Area Walk-By Checklist (AWC)Location: Bldg. CONTROL Floor El. 112 Room, Area¹: TD-T13**Instructions for Completing Checklist**

This checklist may be used to document the results of the Area Walk-By near one or more SWEL items. The space below each of the following questions may be used to record the results of judgments and findings. Additional space is provided at the end of this checklist for documenting other comments.

Figure 1 – Surface Crack at Conduit Support on Wall (Unit 2 Control TD-T13)

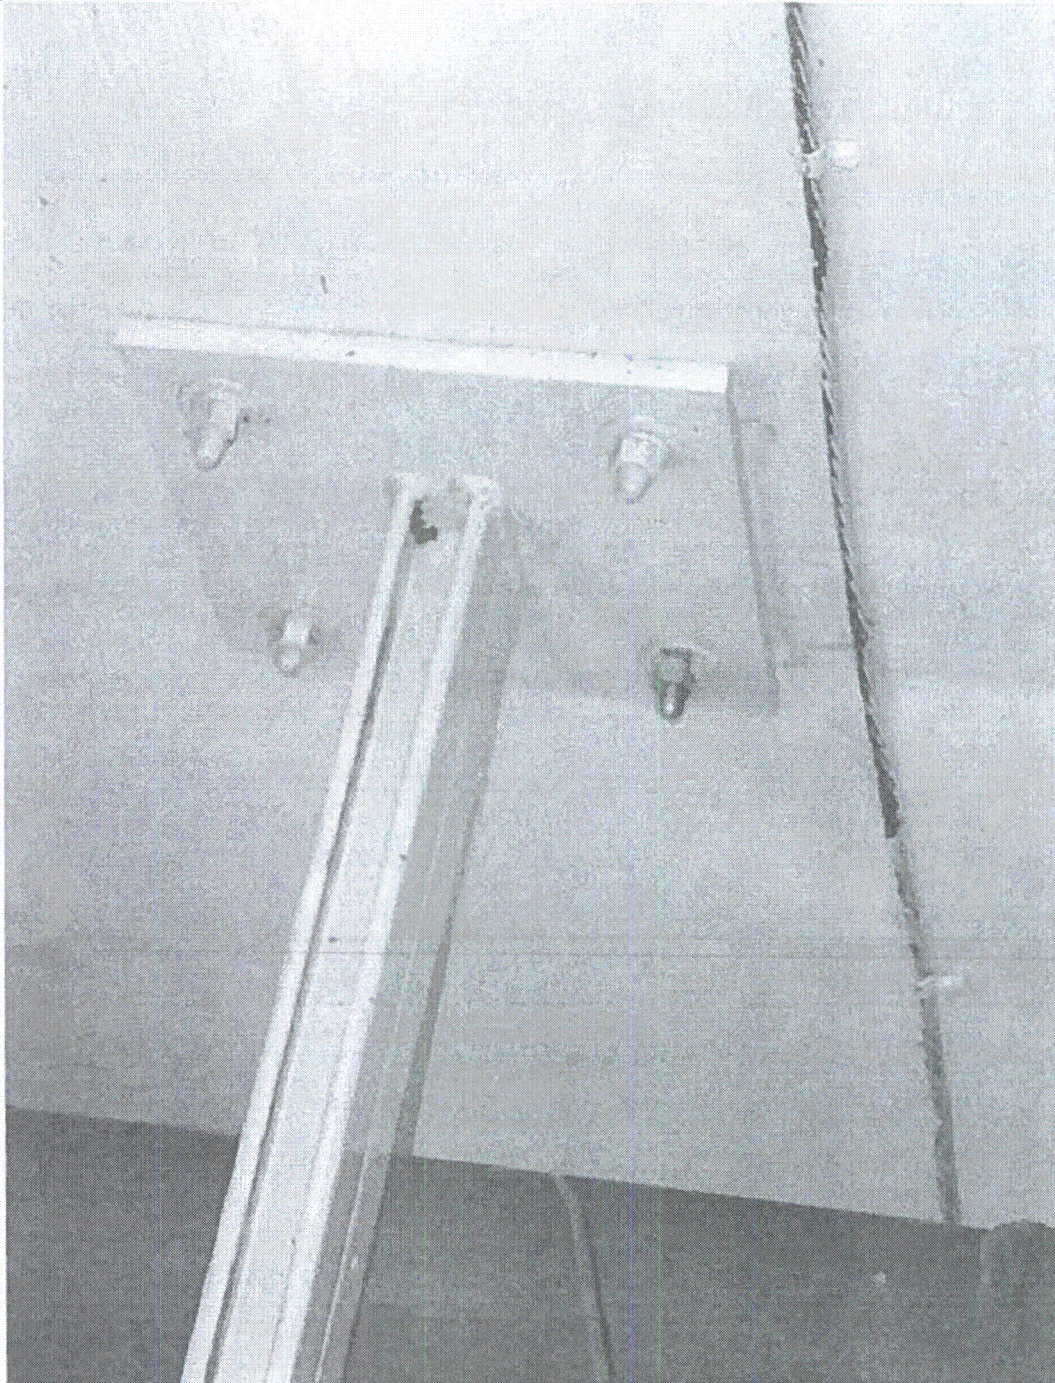
1. Does anchorage of equipment in the area appear to be free of potentially adverse seismic conditions (if visible without necessarily opening cabinets)? Y N U N/A
There is a crack in the concrete at the support for Conduit 2E21611 that appears to extend through the anchor bolt. The crack is a small surface crack and the anchor affected is in compression due to the orientation of the support. Therefore, the crack will not affect the structural adequacy of the anchors and there is no potentially adverse seismic condition.

Figure 2 – HVAC Galvanic Corrosion (Unit 2 Control TD-T13)

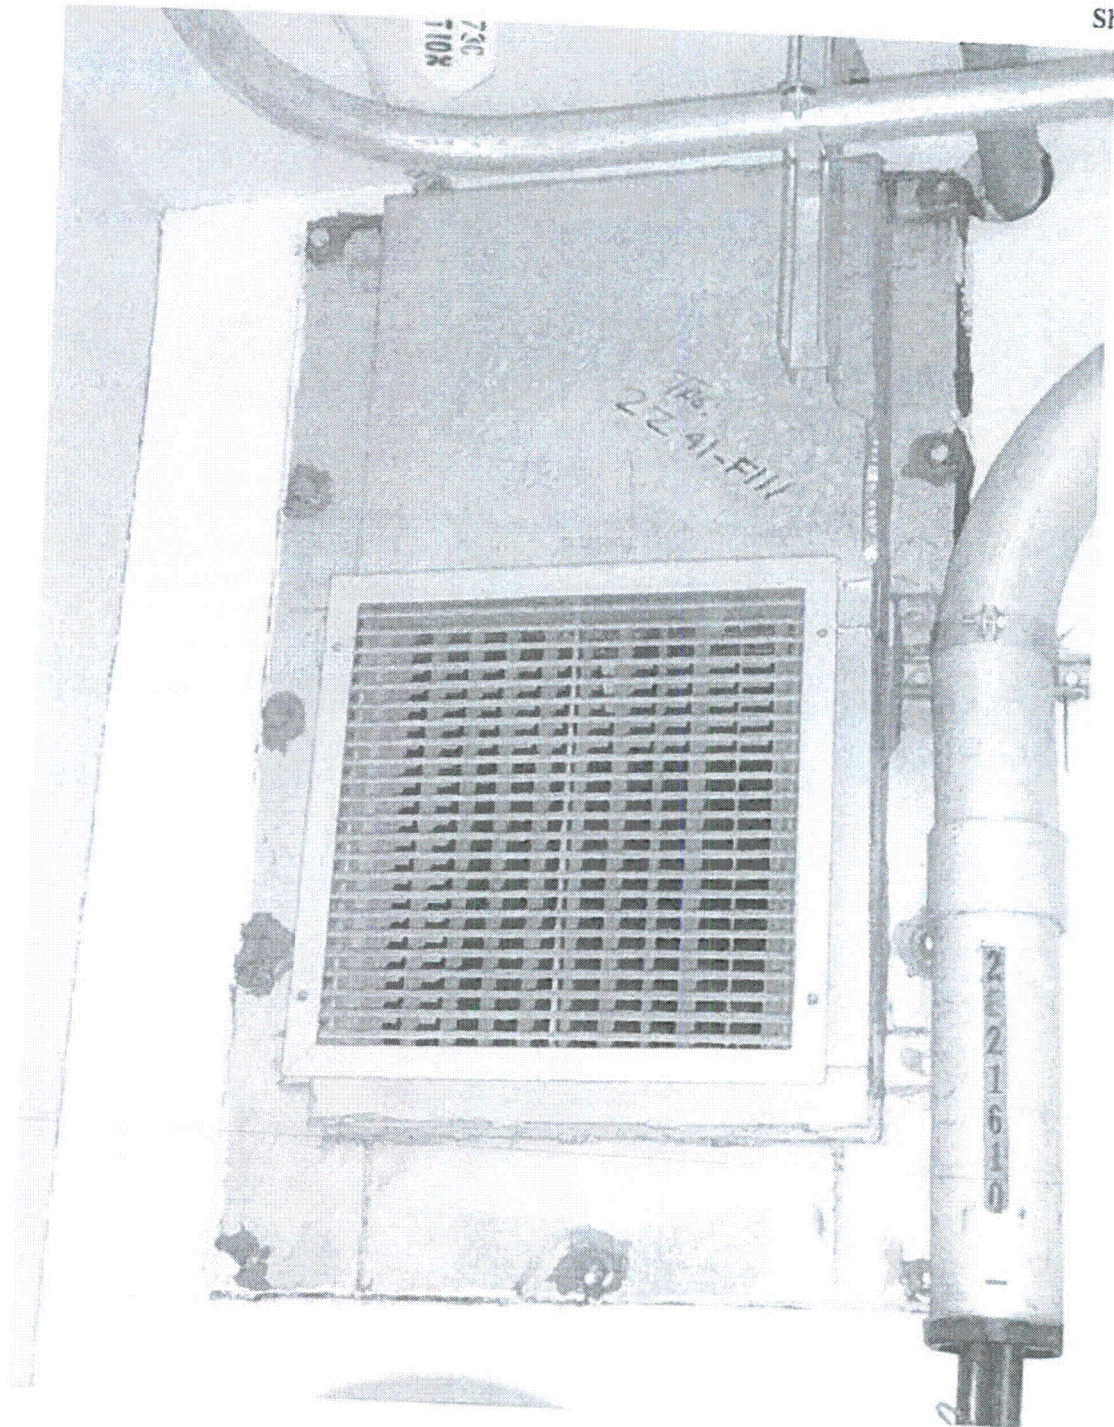
2. Does anchorage of equipment in the area appear to be free of significant degraded conditions? Y N U N/A
There appears to be galvanic corrosion around the anchor bolts for the HVAC support 2Z41-F111. Since the corrosion is only on the surface, the anchors are not impacted. Therefore, there is no potentially adverse seismic condition.
There is a loose nut on a conduit support for Conduit 2E21611 (CR 519680). The support is lightly loaded and the affected bolt will be in compression due to the configuration of the support. Therefore, it is judged that the other three anchors have sufficient strength to restrain the support during a seismic event, so there is no potentially adverse seismic condition.

Figure 4 – Battery Cable and HVAC Spacing (Unit 2 Control TD-T13)

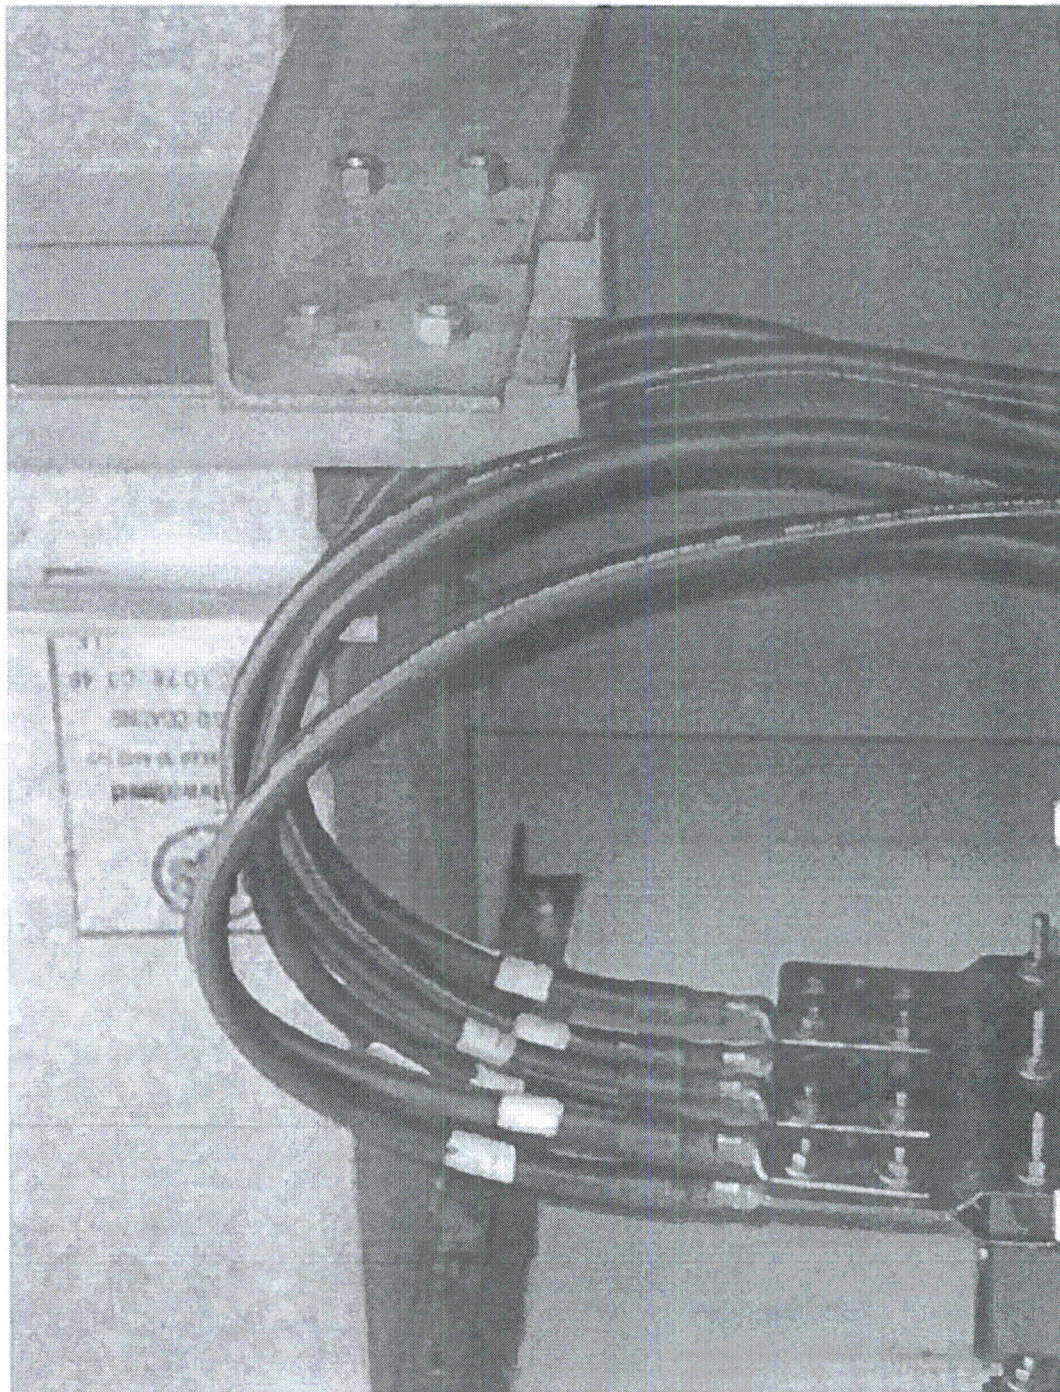
4. Does it appear that the area is free of potentially adverse seismic spatial interactions with other equipment in the area (e.g., ceiling tiles and lighting)? Y N U N/A
The cables for one of the battery racks and the HVAC unit overhead are extremely close to one another. The HVAC unit is very large and rigidly attached to the ceiling, so there will be very little movement of the component and will not have the potential to damage the battery cables. The impact is therefore judged not to be significant, so there is no potentially adverse seismic condition.

1: Cracks on West Wall (Battery Room 2A)

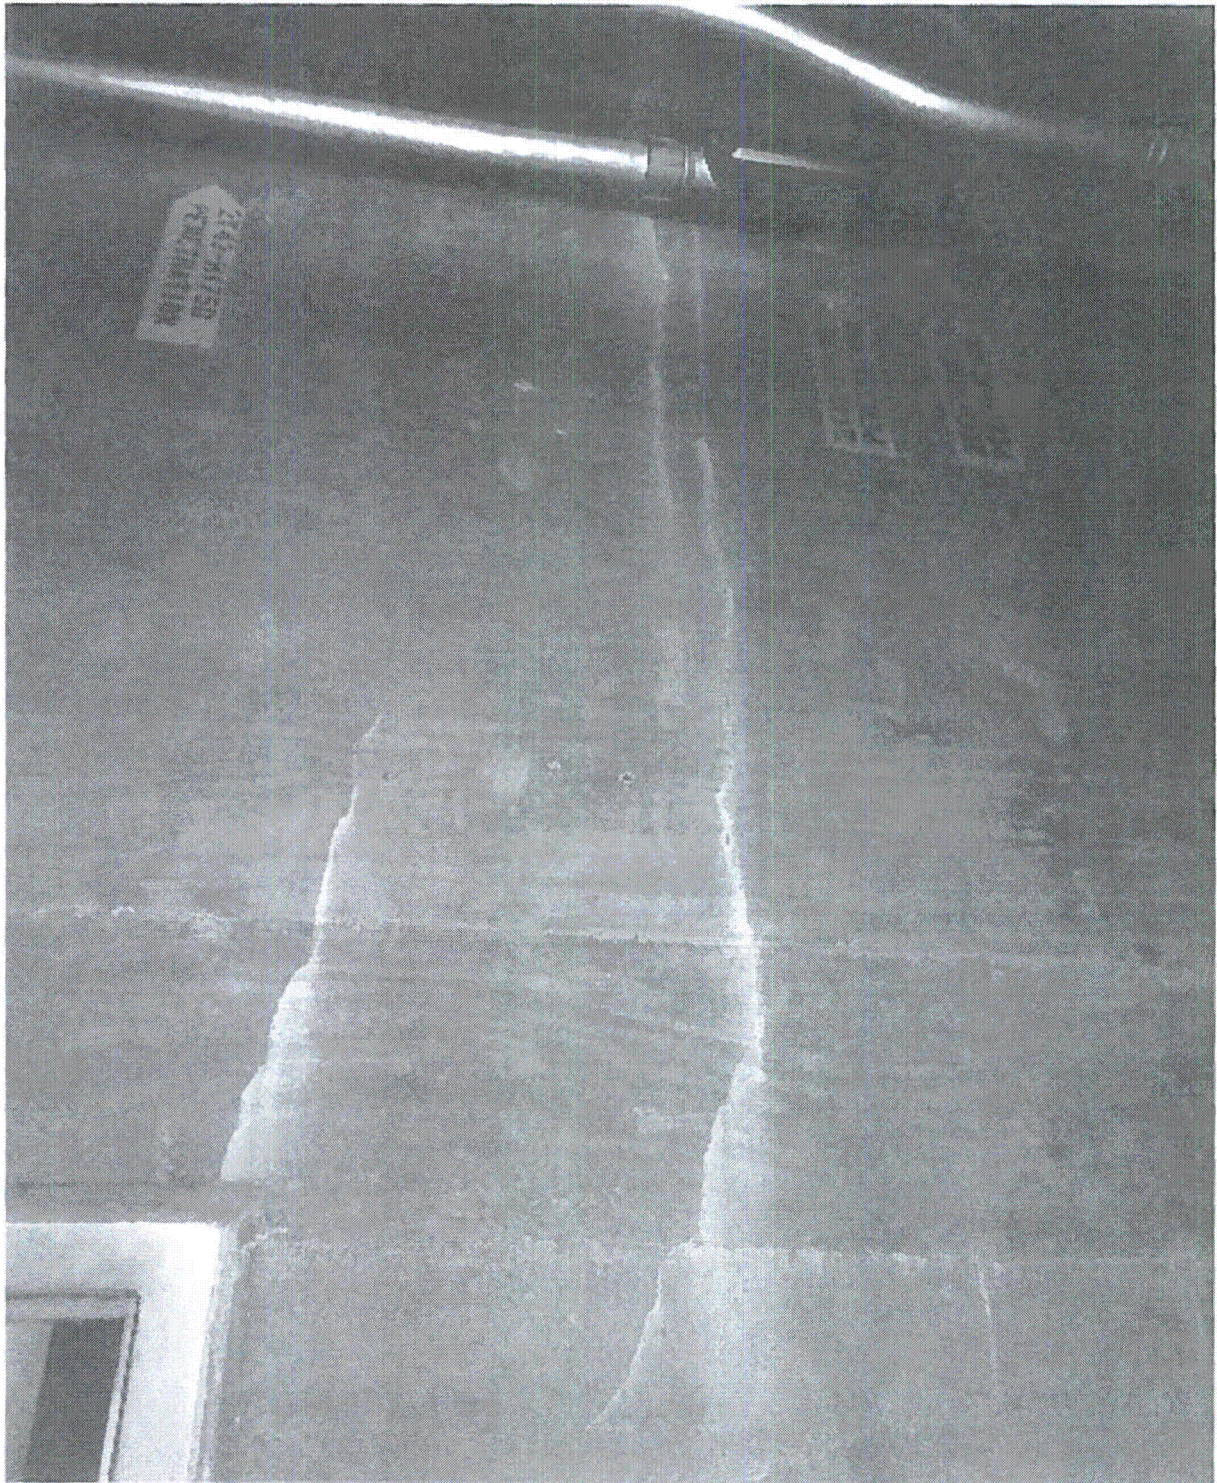
8. Have you looked for and found no other seismic conditions that could adversely affect the safety functions of the equipment in the area? Y N U
The west wall exhibited cracks above the door opening to the room. These cracks do not appear to go through any anchors to equipment mounted on the wall (see photograph 1). This is judged to not be a seismic concern.

1: Unattached Ground Cable to 2H21-P293 (Battery Room 2C)

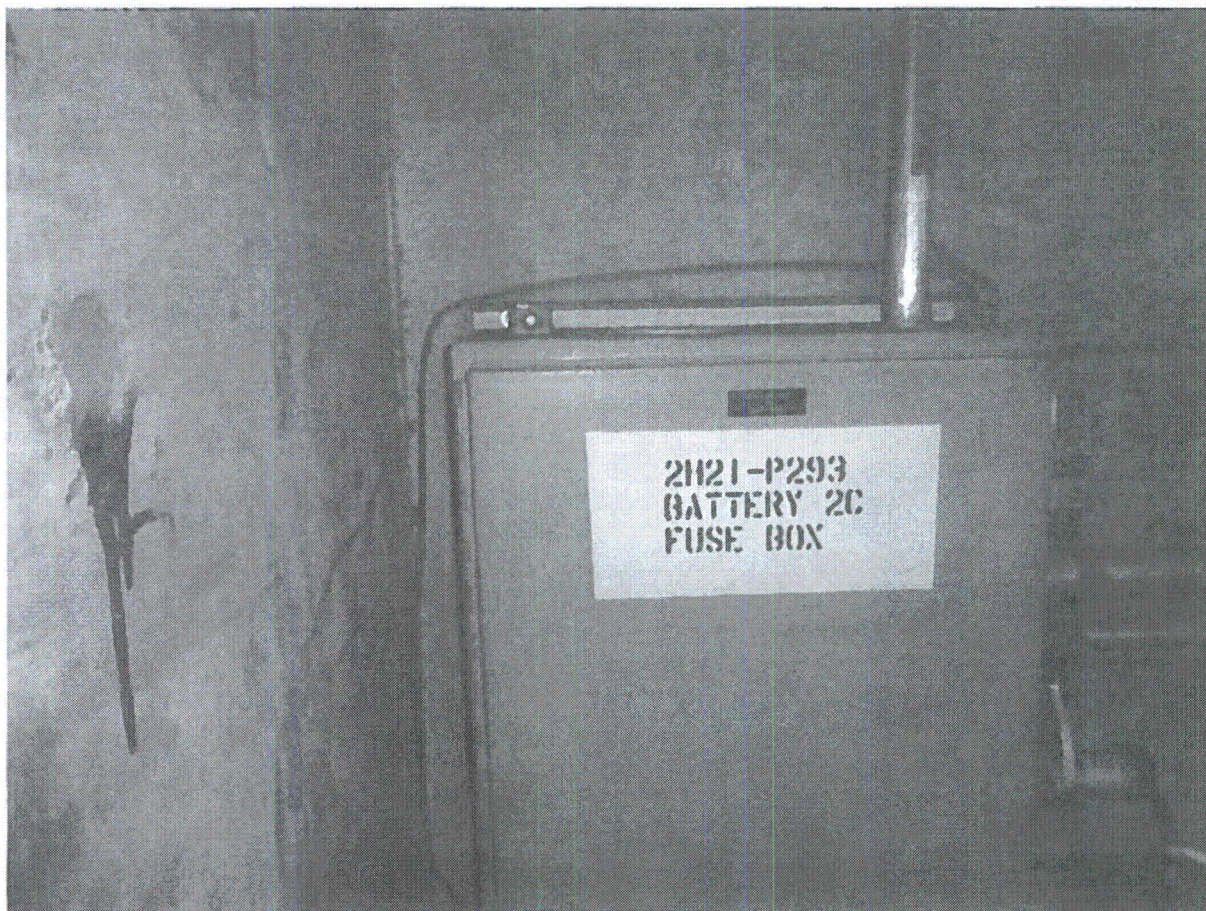
There is a grounding wire not attached to anything from battery fuse box 2H21-P293 (see photographs 1 and 2). This is not a seismic concern. There is another ground cable from the same box which is connected to the ground loop. The unattached ground cable doesn't appear to be required. CR 523485 has been written to resolve this issue.

Figure 1 – Difficult to See Nut on Anchor Bolt (Room C-027)

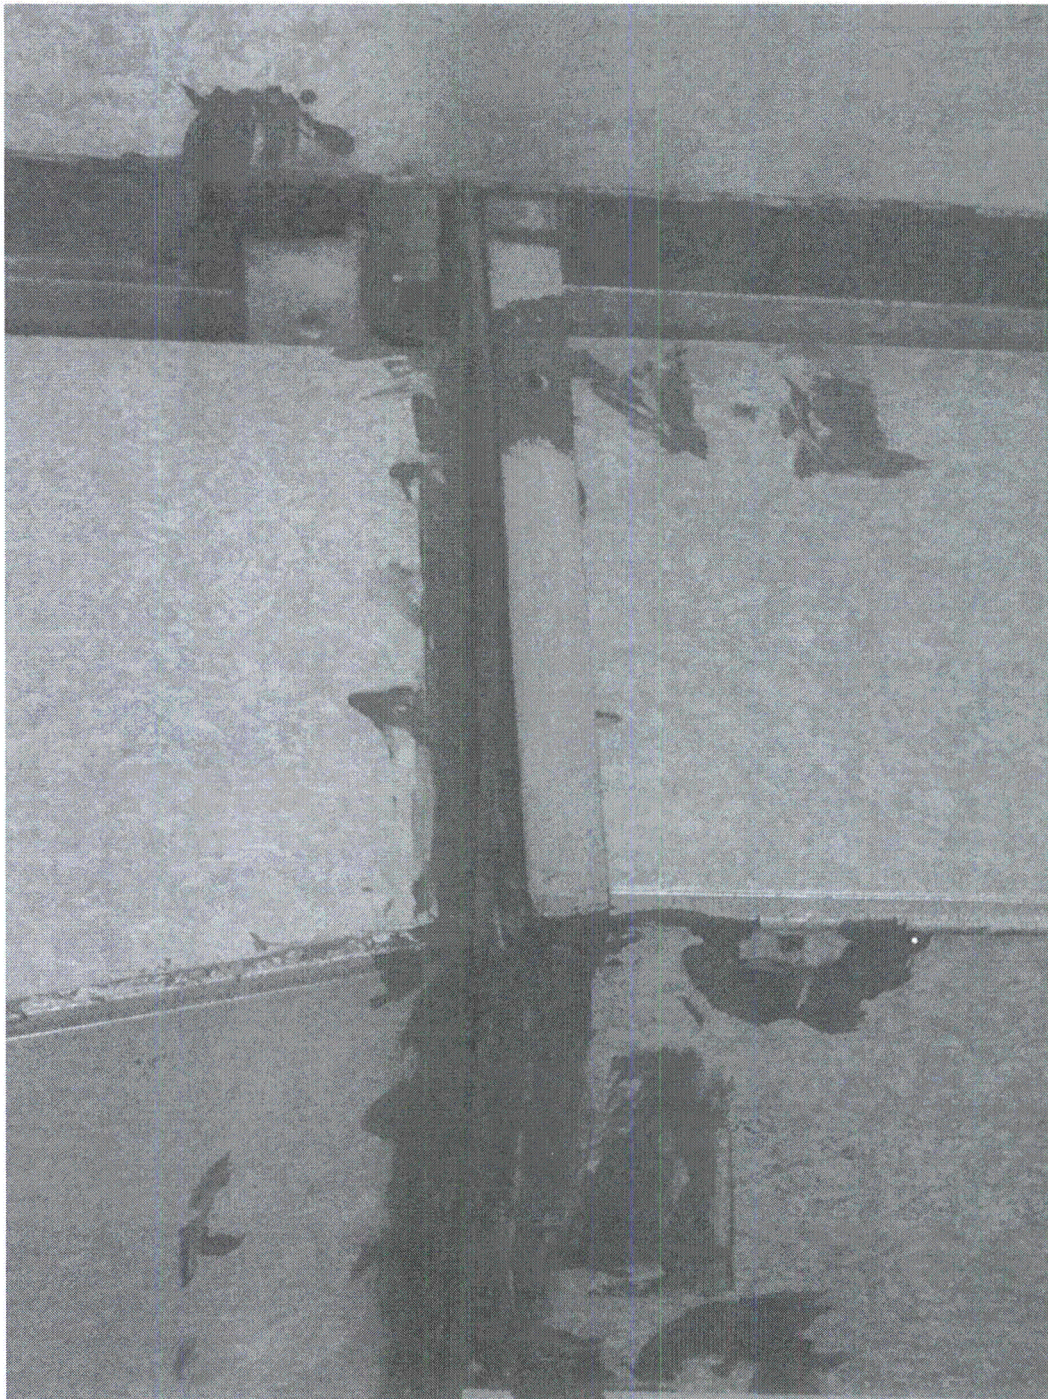
The top right bolt on the HVAC support over the room door appears to be missing a nut. On closer inspection, it was determined that the nut is new and so blends in to the support from the front, but is visible from an angle. Since no hardware is missing, there is no potentially adverse seismic condition.

Figure 2 – Missing Screw on HVAC Strap (Room C-027)
(Note: Hole in strap on top of HVAC, at top left of picture, is a misdrilled hole that was not utilized. No screw is missing from this strap.)

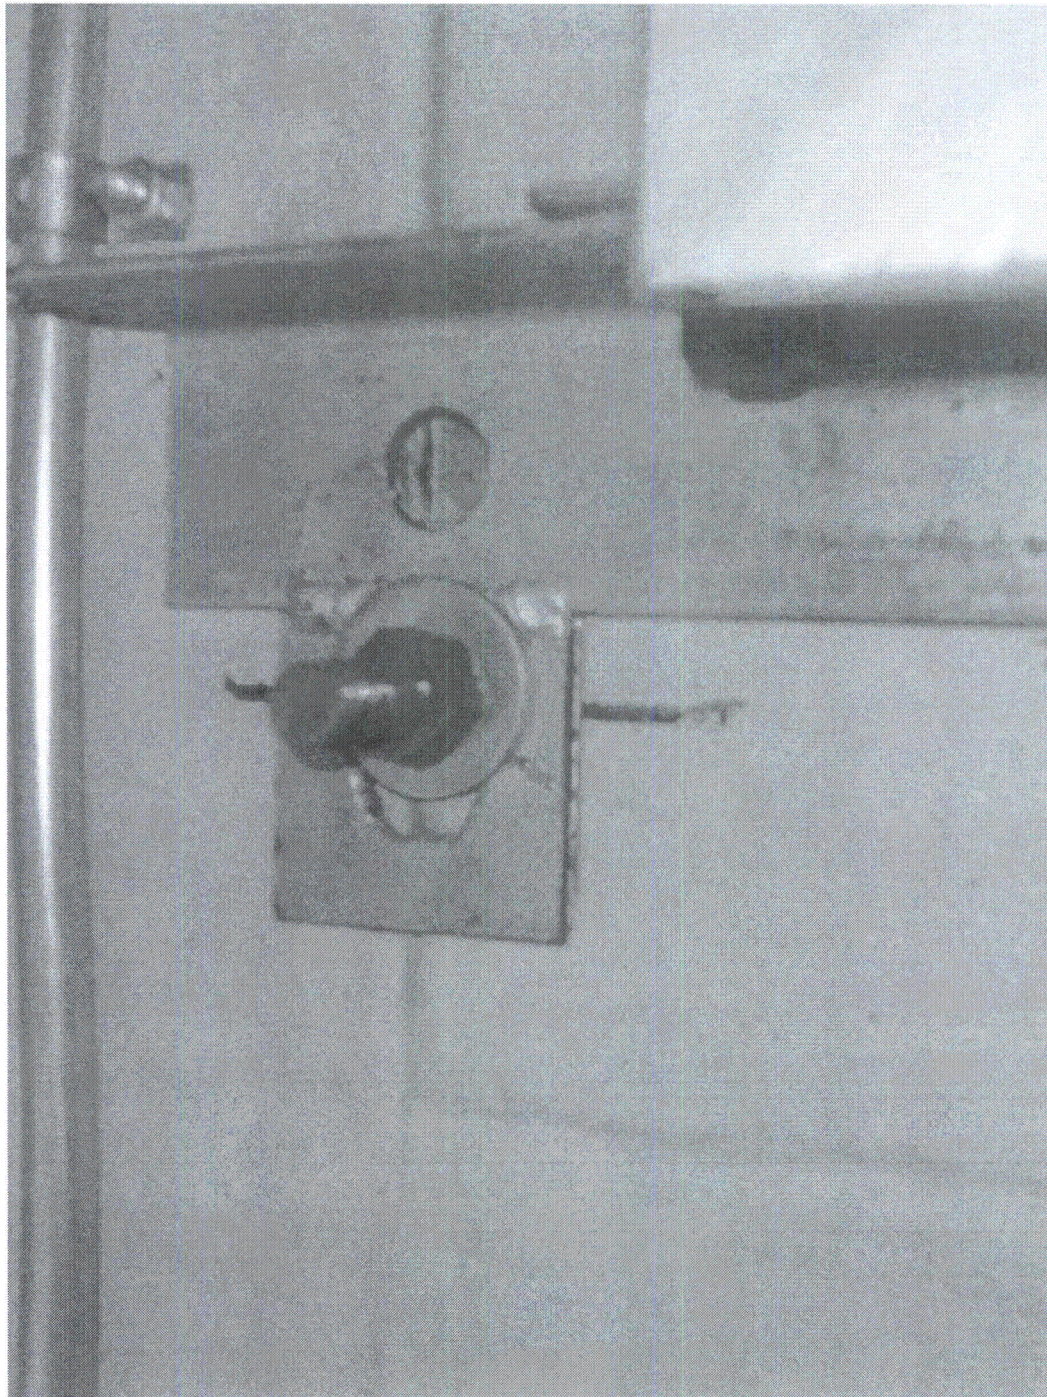
There is a screw missing on the side of the HVAC strap near Penetration 2Z43-H182C (CR 524311). The strap is screwed to the HVAC on the bottom of the strap. The single remaining screw is judged adequate to maintain the connection between the strap and the HVAC, so there is no potentially adverse seismic condition. However, in accordance with good engineering practice, the screw should be replaced so there are two screws for the support.
